DOCKET 50-255 - LICENSE DPR-20 - PALISADES NUCLEAR PLANT
WITHDRAWAL OF RELIEF REQUEST TO PERFORM WELD OVERLAY REPAIRS
ON CONTROL ROD DRIVE MECHANISM (CRDM) UPPER HOUSINGS; AND
RESTATEMENT OF RESPONSES CONCERNING WELD NO. 1 (TAC NO. MB3001)

**Response to Request for Additional Information Regarding Weld No. 1 (Reactor
Vessel Head Nozzle Pipe to Flange Weld) as provided November 6, 2001**

**Follow-up Questions Regarding Weld No. 1 (Reactor Vessel Head Nozzle Pipe to
Flange Weld) as provided November 17, 2001**

WELD 1/THERMAL SLEEVE:

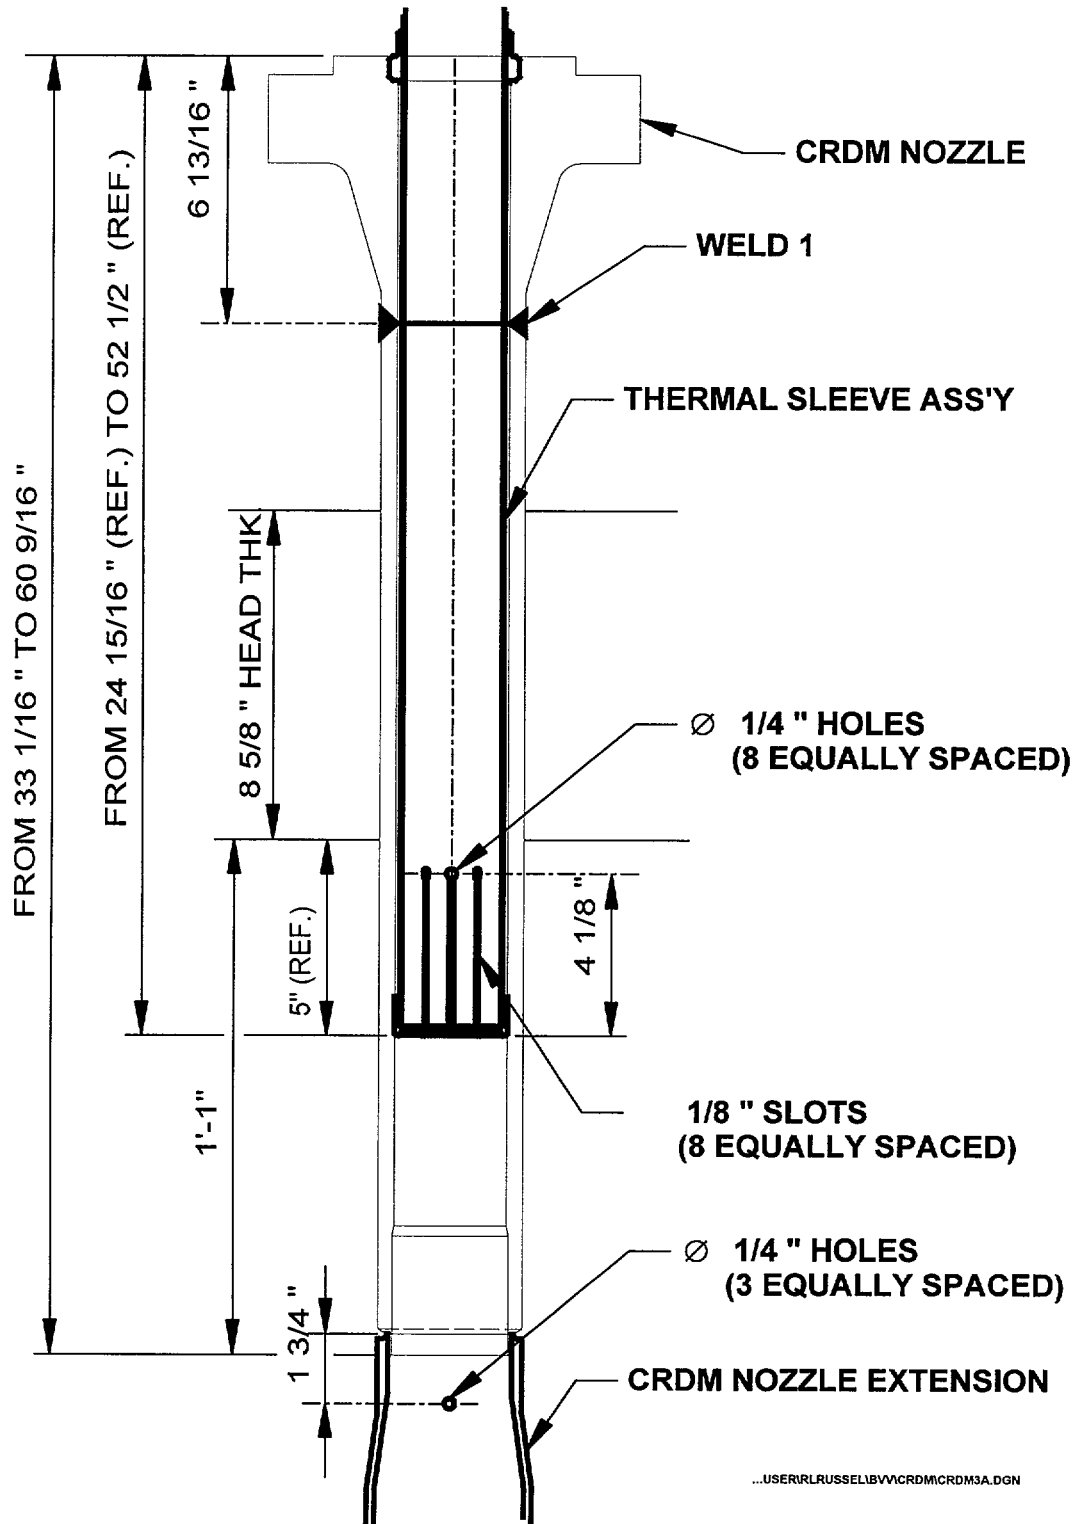
Regarding the holes in the thermal sleeve, provide a sketch showing their location relative to Weld No. 1. It is not apparent why there would be flow in the thermal sleeve annulus in the vicinity of Weld No. 1.

The attached sketch shows the location of flow holes. The subject flow holes are not in the thermal sleeves themselves. The three ¼ inch diameter flow holes exist within each CRDM nozzle tube assembly. They are located about 13 inches from the inside of the reactor head. Due to the presence of the upper guide structure between the fuel and the nozzle tube ends, a portion of the reactor coolant flow proceeds upward into the nozzle tube assemblies and out of the three ¼ inch diameter flow holes. In addition to this, a temperature gradient exists between the inside of the thick vessel head and Weld No. 1. This temperature gradient will promote some convective flow within the annulus surrounding the thermal sleeve as would occur in any environment where a temperature gradient exists.

Although the flow between the two scenarios is limited, fluid exchange will occur at some rate within the annulus, causing residual oxygen (from vessel fill) to be lessened within the annulus.

Weld Number 1

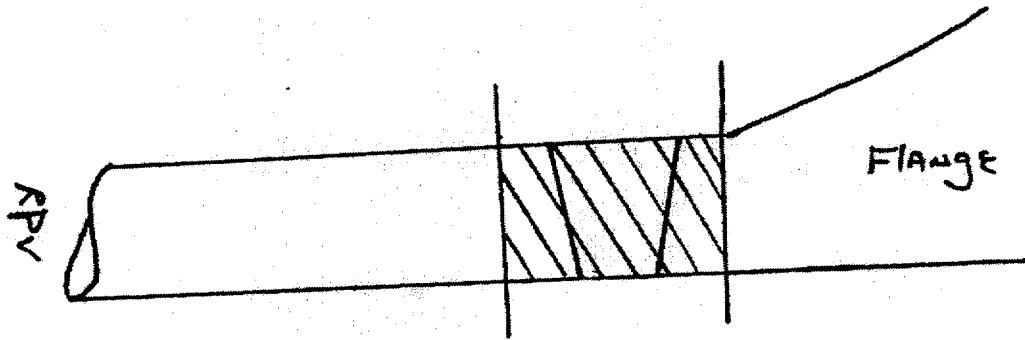
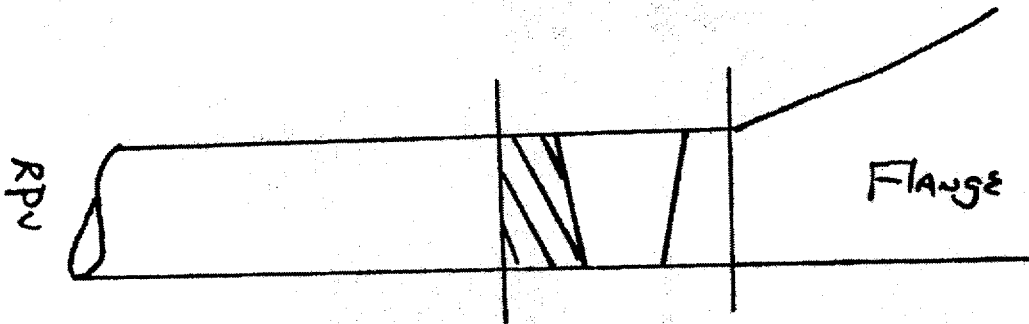
Provide a cross-section of the weld showing the volume that was inspected using qualified procedures and personnel. Show the volume that was inspected using a best effort UT procedure and personnel:

See the attached sketch.

REQUIRED EXAM
VOLUME

AREA EXAMINED
